CITY OF SURPRISE
Planning and Zoning Commission Agenda
16000 N. Civic Center Plaza
Surprise, AZ 85374

Case: FS15-249

Project Name: Iris USA

A. The Site Plan prepared by Ware Malcomb dated 7/31/15 will be revised and submitted for review to include the following modifications:

SHEET
A1.1c

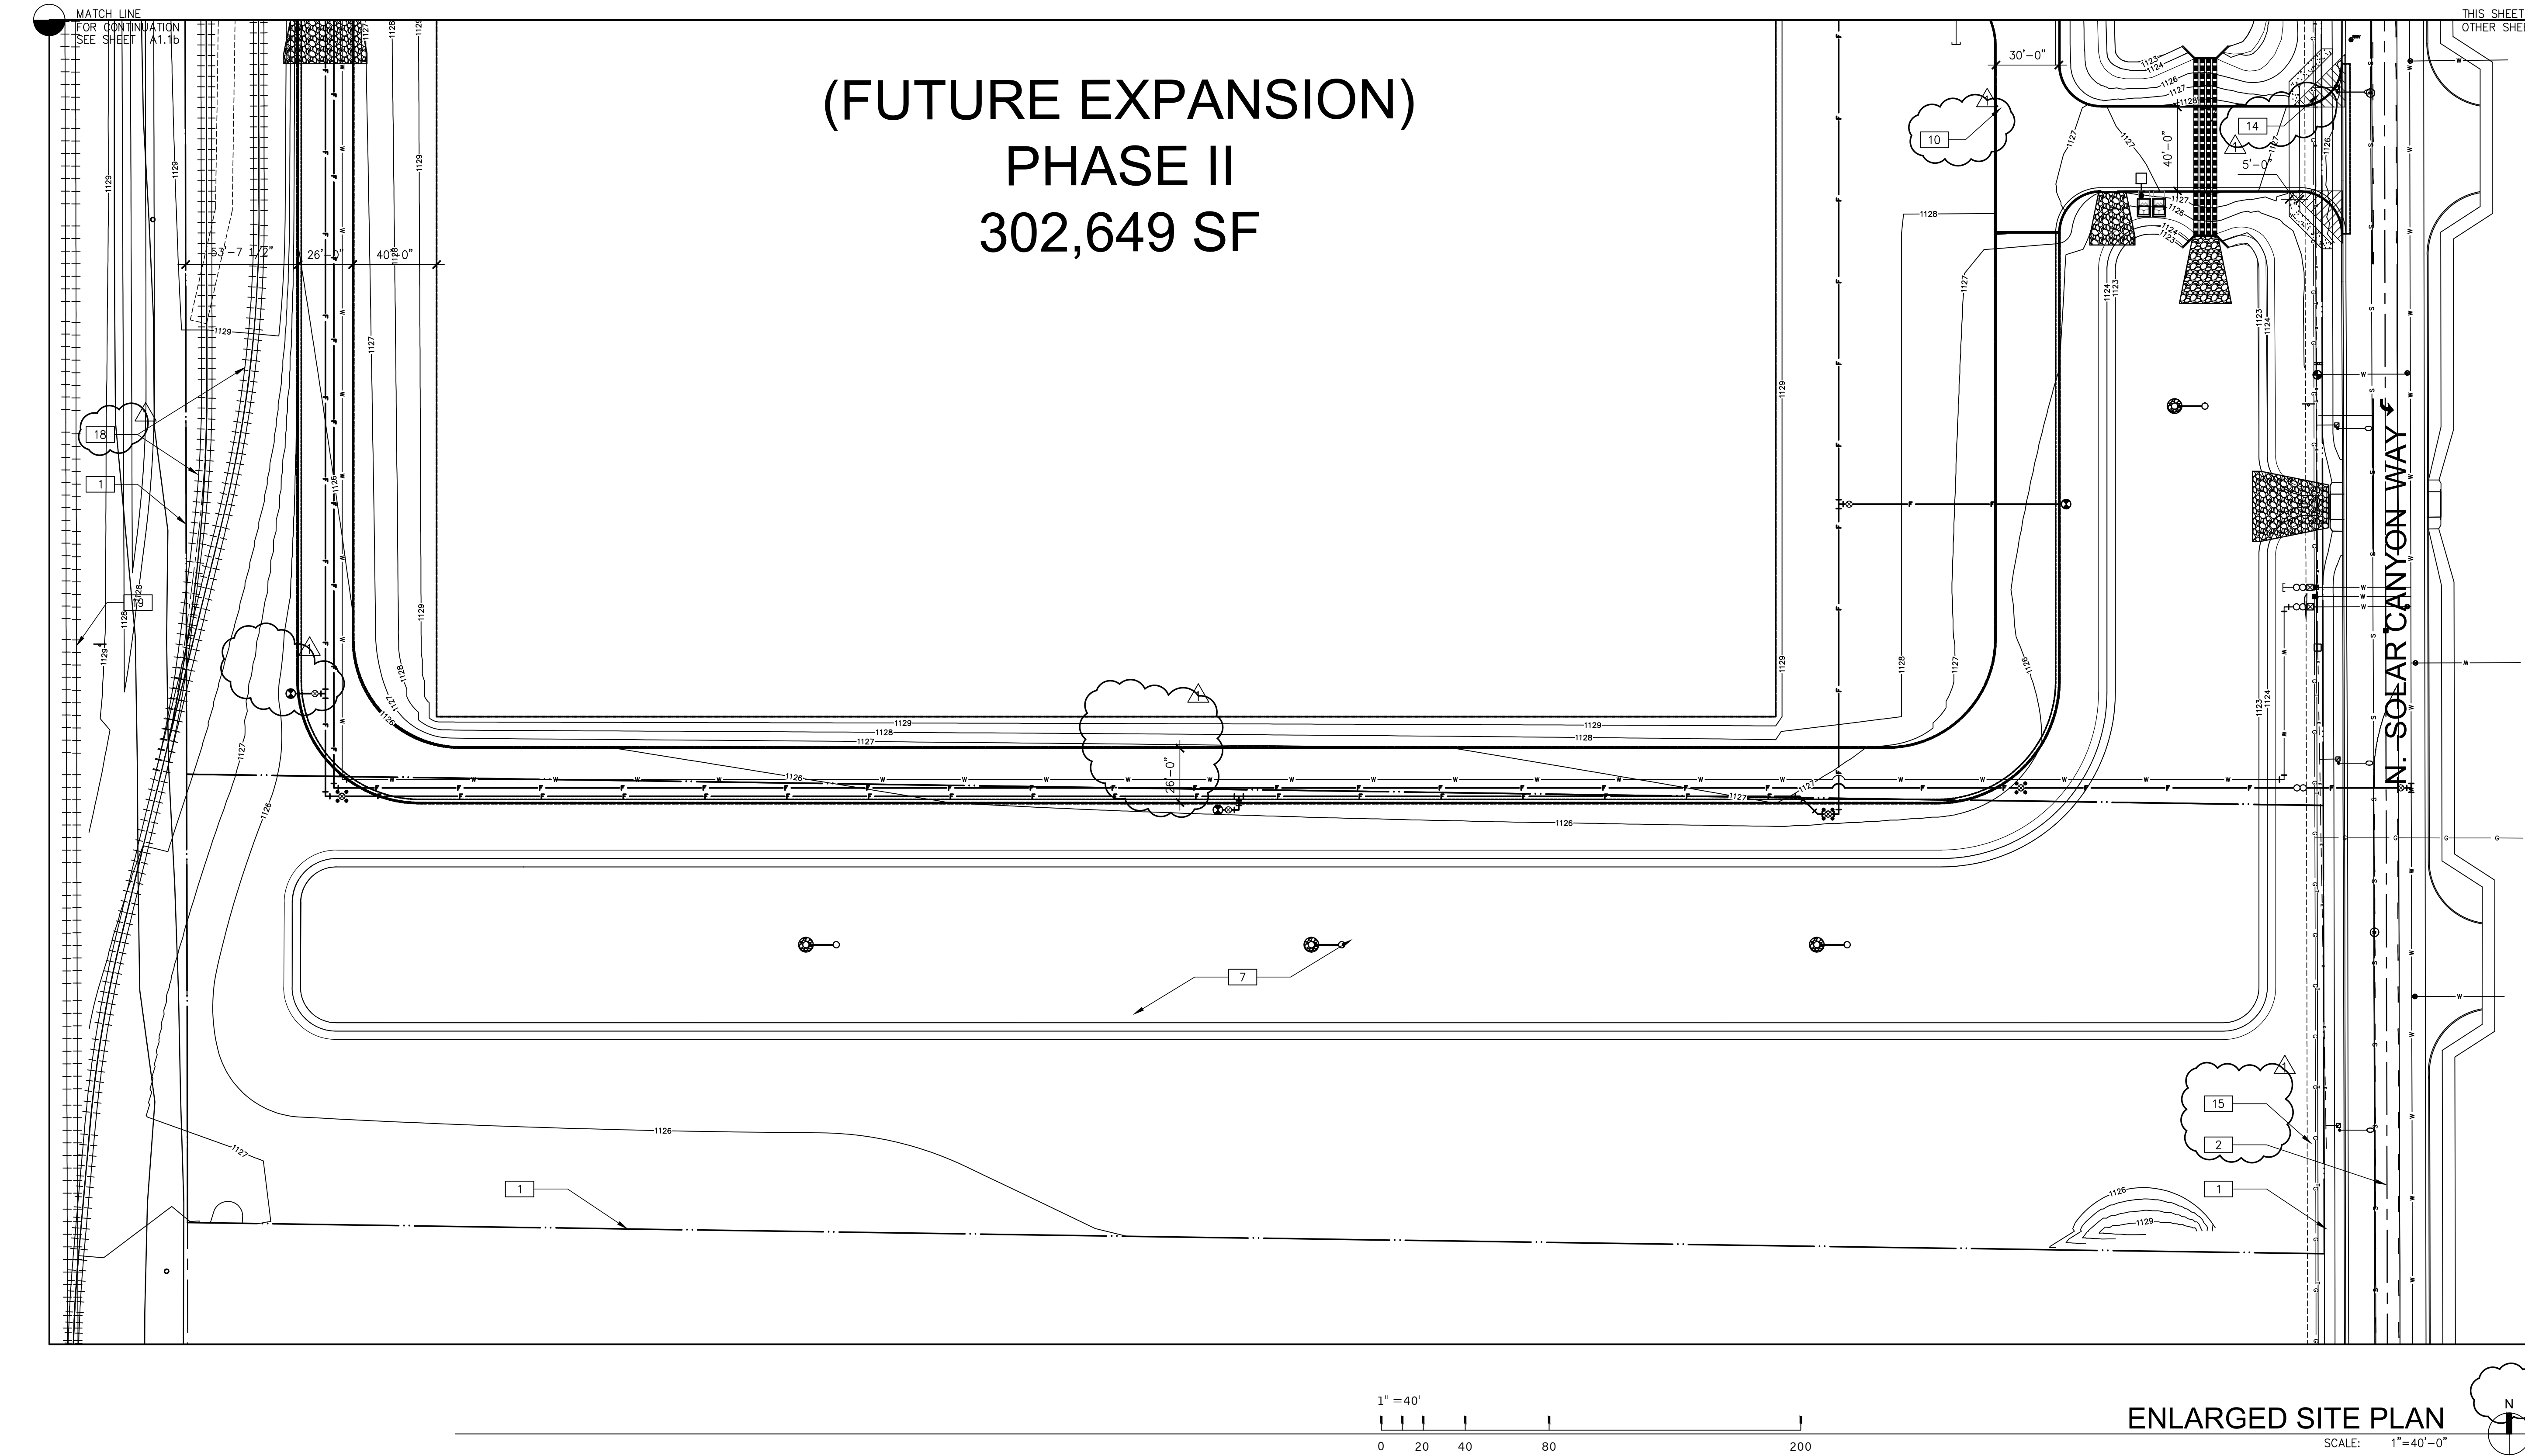
9. Provide applicable notes only
10. Provide high water elevation

SHEET 1 OF 1
PL0.01

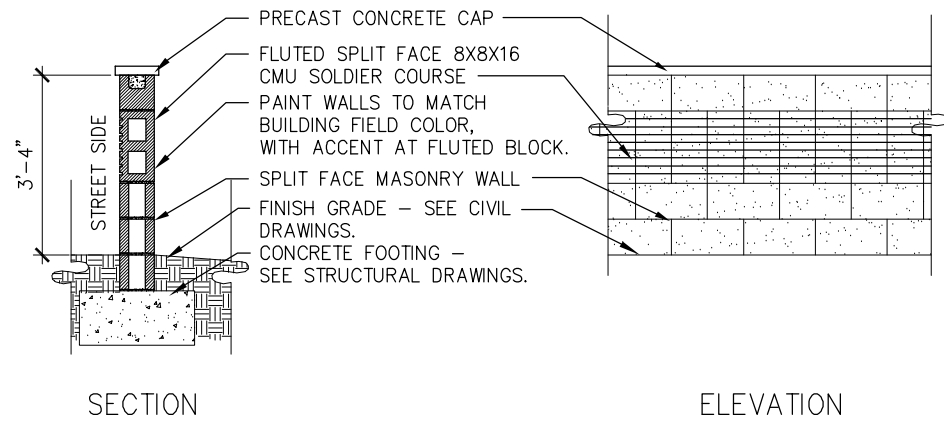
1. Provide sight visibility lines per City of Surprise Engineering Development Standards **Detail 4-01** at all drives. Verify that existing and proposed vegetation meet the criteria of this detail. Provide the visibility line at the west drive from Cactus Road based on the ultimate roadway section.

2. It appears the sight visibility triangles included on the latest submittal are calculated from Detail 4-02, not Detail 4-01. Provide sight visibility lines, as calculated from Detail 4-01 in the Engineering Development Standards. Include a sight visibility line at Cactus Road and Solar Canyon Way as well.
- C. The Irrigation Plan prepared by Studio DPA, dated 7/31/15 will be revised and submitted for review to include the following modifications:
